\*\*\* ACTION REQUEST \*\*\*

EVAL DESC: TECHNICAL BASIS FOR AWA FOR ECR 06-00879

THIS TECHNICAL EVALUATION PROVIDES THE TECHNICAL BASIS PRK1 25OCT06  
FOR THE ADVANCED WORK AUTHORIZATION ASSOCIATED WITH ECR PRK1 25OCT06  
06-00879 FOR CAULKING THE JOINT AT THE OUTBOARD PERIMETER PRK1 25OCT06  
OF THE ELEV. 10'-3" DRYWELL CONCRETE SLAB CURB AND THE PRK1 25OCT06  
DRYWELL STEEL SHELL. THE EVALUATION WILL EXAMINE THE PRK1 25OCT06  
IMPACT OF THE ADDITION OF THE PROPOSED CAULKING ON THE PRK1 25OCT06  
DESIGN BASIS ANALYSIS (REFERENCE 2) FOR SUCTION STRAINER PRK1 25OCT06  
DEBRIS GENERATION AND TRANSPORT. THIS SCOPE OF THIS PRK1 25OCT06  
TECHNICAL EVALUATION IS LIMITED TO PROVIDING THE PRK1 25OCT06  
TECHNICAL BASIS FOR AWA AND SHALL NOT BE USED FOR PRK1 25OCT06  
TURNOVER TO OPERATION. PRK1 25OCT06

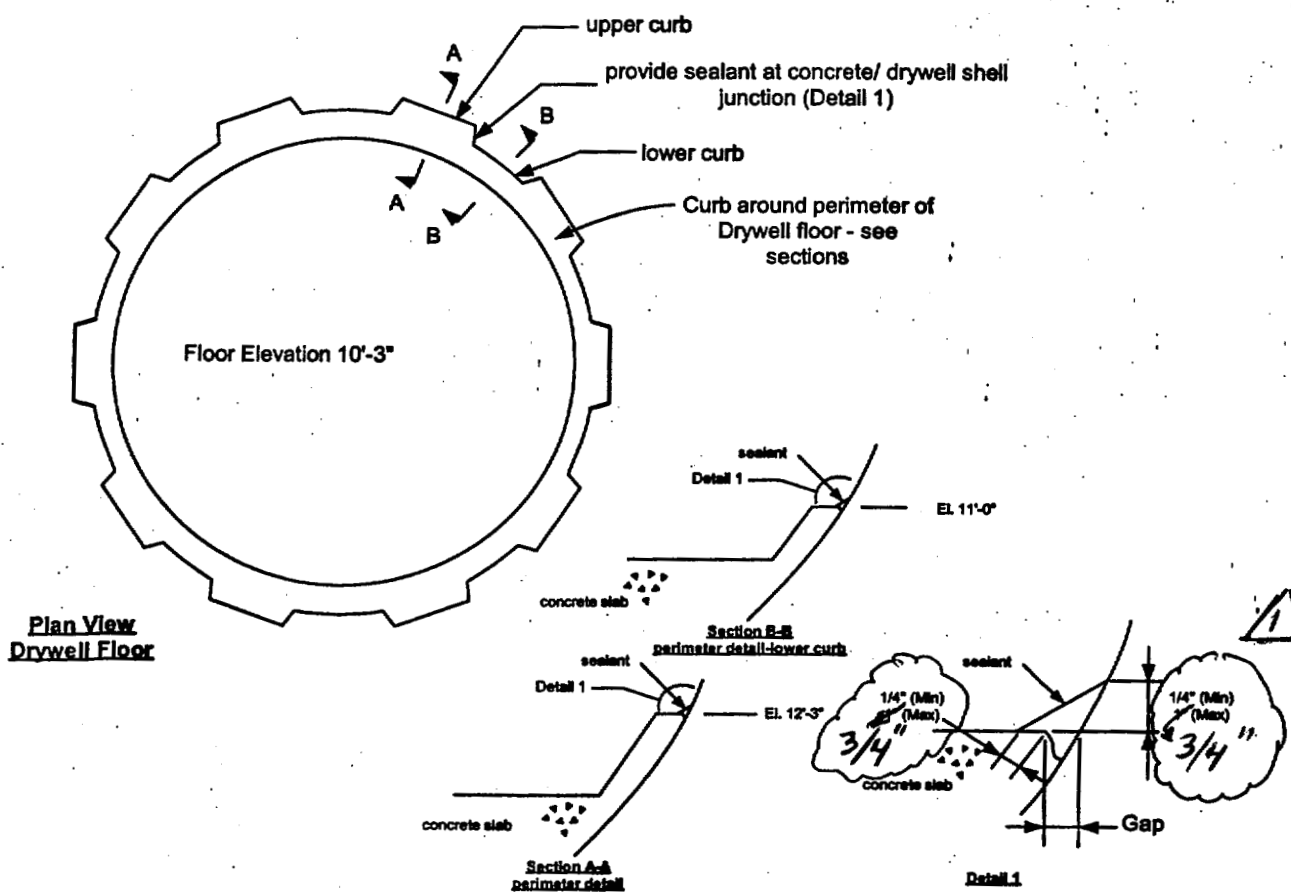
INDEPENDENT REVIEWER COMMENTS: PERFORMED BY DAN FIORELLO DJF2 27OCT06  
 ATTACHMENT 1 WAS REVISED TO DECREASE THE MAXIMUM SIZE OF DJF2 27OCT06  
 THE CAULK JOINT TO 3/4 INCH. THIS CHANGE DECREASES THE DJF2 27OCT06  
 AMOUNT OF CAULIKING MATERIAL TO 522 FLUID OUNCES OR 51.3 DJF2 27OCT06  
 POUNDS OF THIOKOL 2235M. DURING A DBLOCA THE GENERATED DJF2 27OCT06  
 DEBRIS OF CURED CAULK WILL THEREFORE CHANGE FROM 20 DJF2 27OCT06  
 POUNDS TO 13 POUNDS. I HAVE REVIEWED THE EVALUATION AND DJF2 27OCT06  
 ATTACHMENTS AND AM IN AGREEMENT WITH THE EXCEPTION OF THE DJF2 27OCT06  
 TEMPERATURE LIMITS. THE MATERIAL IS BEING TESTED BY DJF2 27OCT06  
 POWER LABS AND THESE TESTS INCLUDE TESTING OF THE CAULK DJF2 27OCT06  
 TO WITHSTAND A TEMPERATURE OF 317 DEGREES FOR 600 DJF2 27OCT06  
 SECONDS. DJF2 27OCT06  
 THIS EVALUATION SHOULD NOT BE RETURNED UNTIL THE DJF2 27OCT06  
 CAULK HAS PASSED THE REQUIRED TESTING. DJF2 27OCT06

Using a caulk bead 1" high and a gap equal to 0.3" (approximate gap due to deterioration at the corner of the concrete slab) and caulk extending 1" horizontally beyond the gap (see Detail 1).

$$\text{Area} := \frac{(\overset{.75}{1} \cdot \text{in}) \cdot (\overset{1.05}{1.3} \cdot \text{in})}{2} + \frac{(0.3 \cdot \text{in}) \cdot (0.3 \cdot \text{in})}{2}$$

$$\text{Area} = \cancel{0.695 \text{ in}^2} \quad .439$$
